CITY of MEDINA
Planning Commission
February 11, 2016 Meeting

Case No:	P16-01
Address:	133 Commerce Drive
Applicant:	Joel Copley
Subject:	Site Plan Review – Parking lot expansion Sandridge Food Corporation
Zoning:	I-1 Industrial District
Submitted by:	Justin Benko – Associate Planner JB

ELECTRICAL SITE PLAN

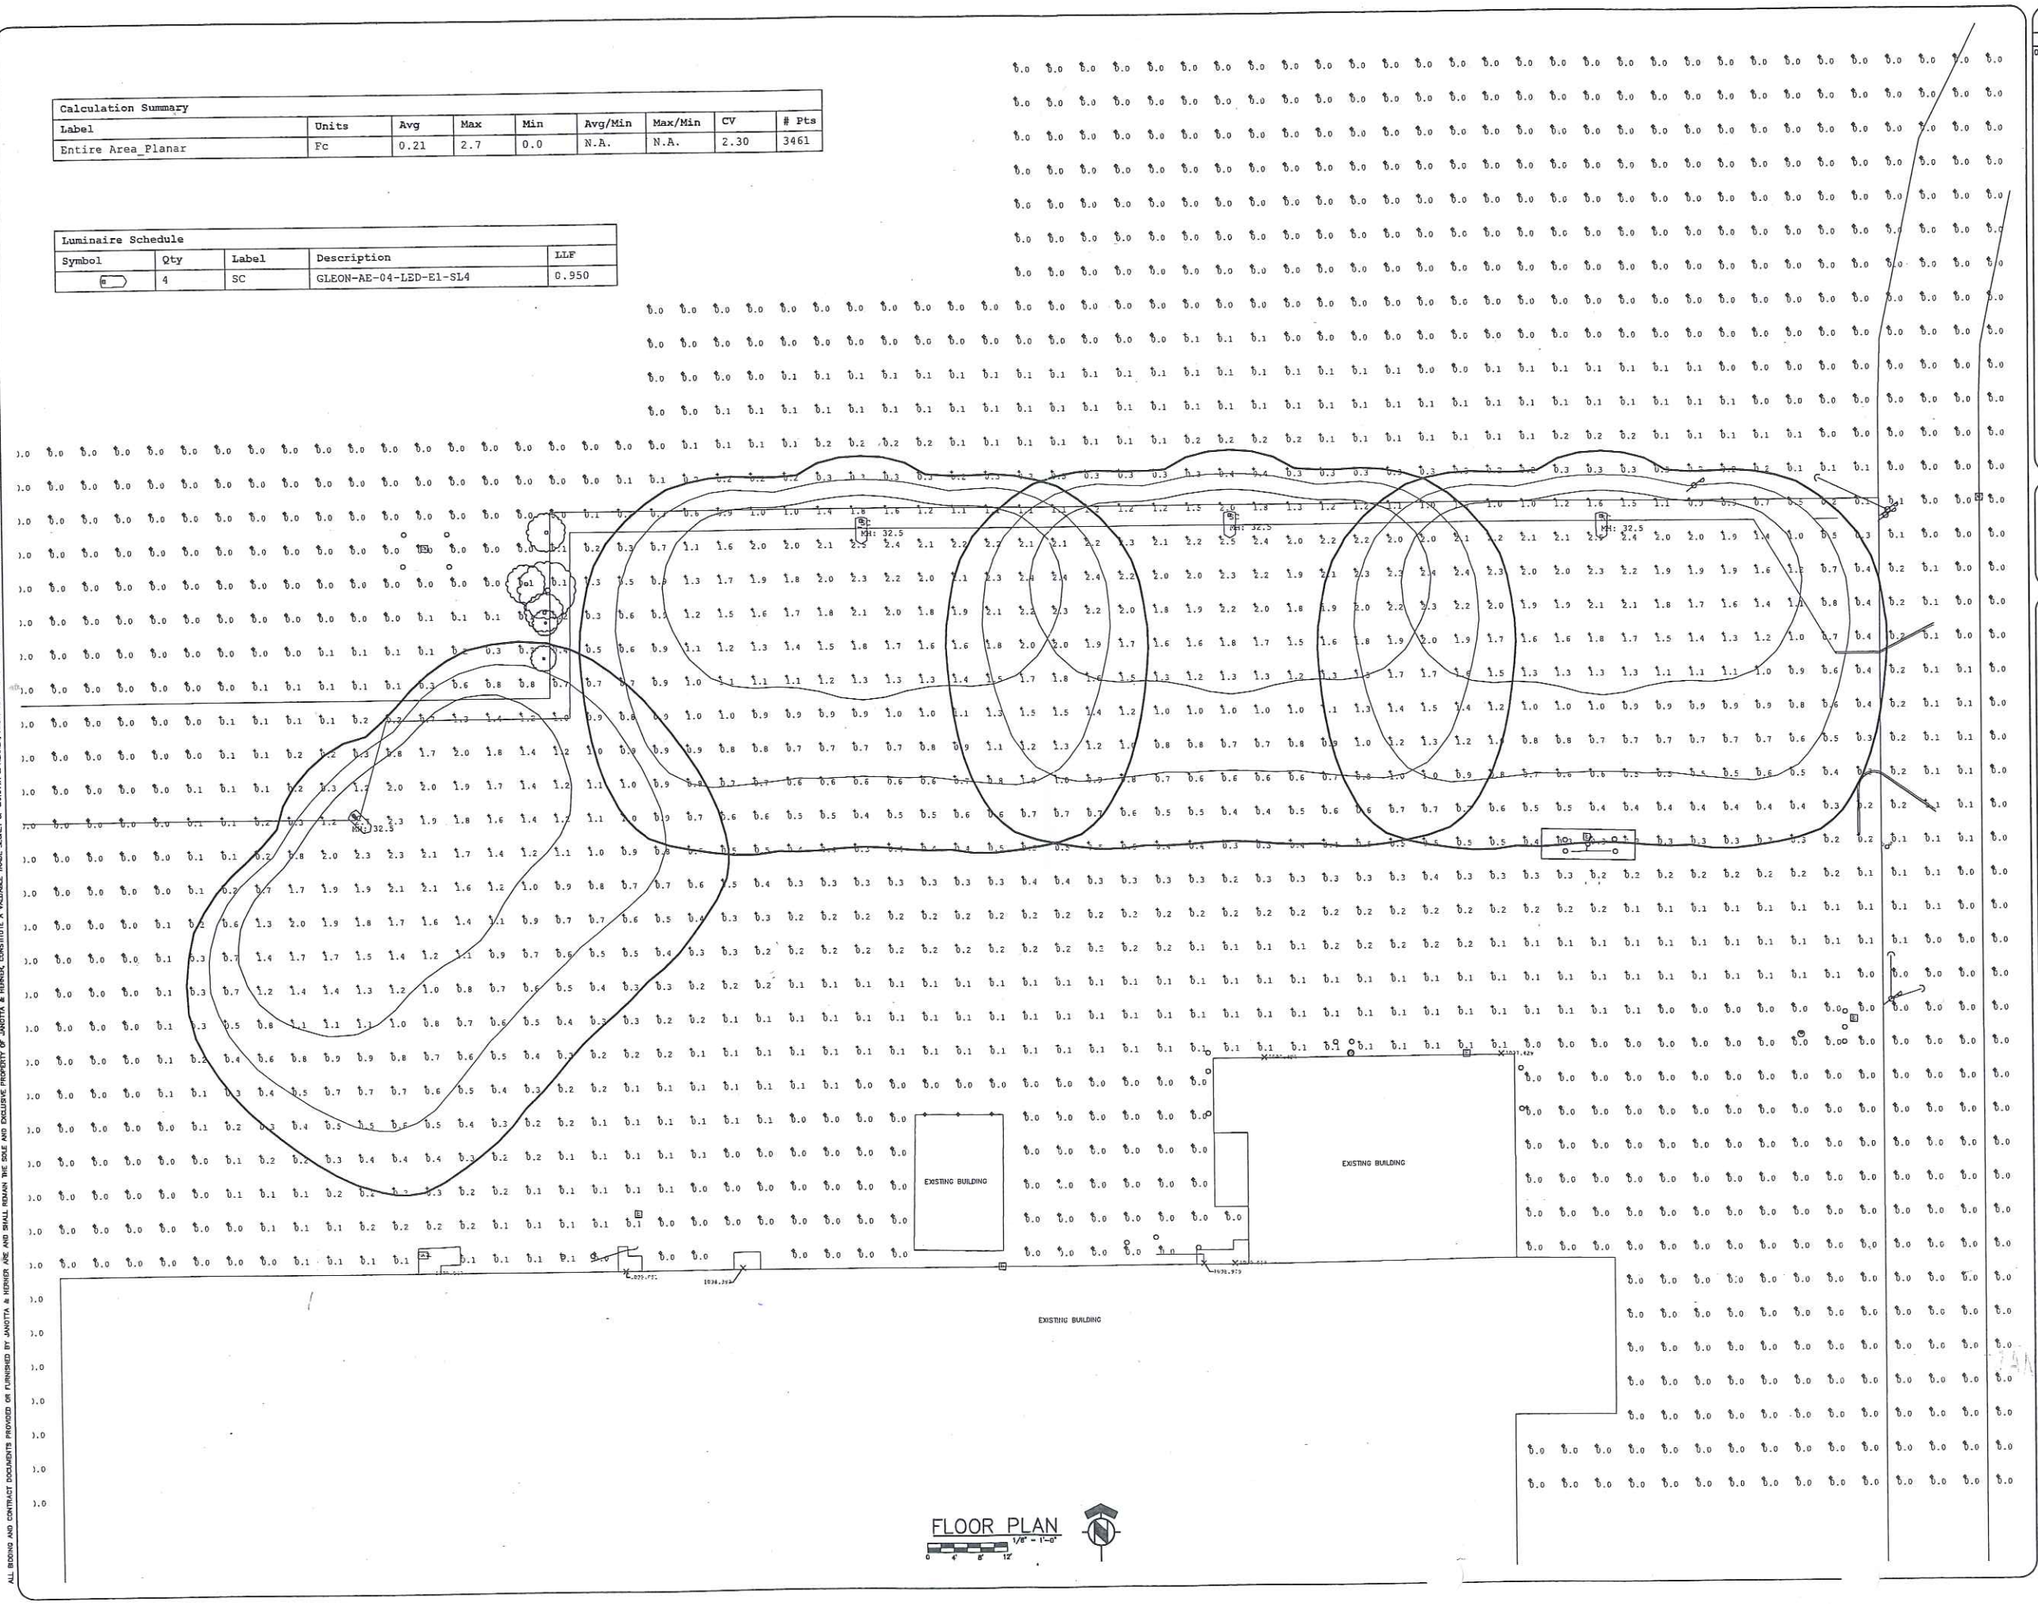
Lighting: The applicant has submitted a code compliant lighting plan for the parking lot expansion.
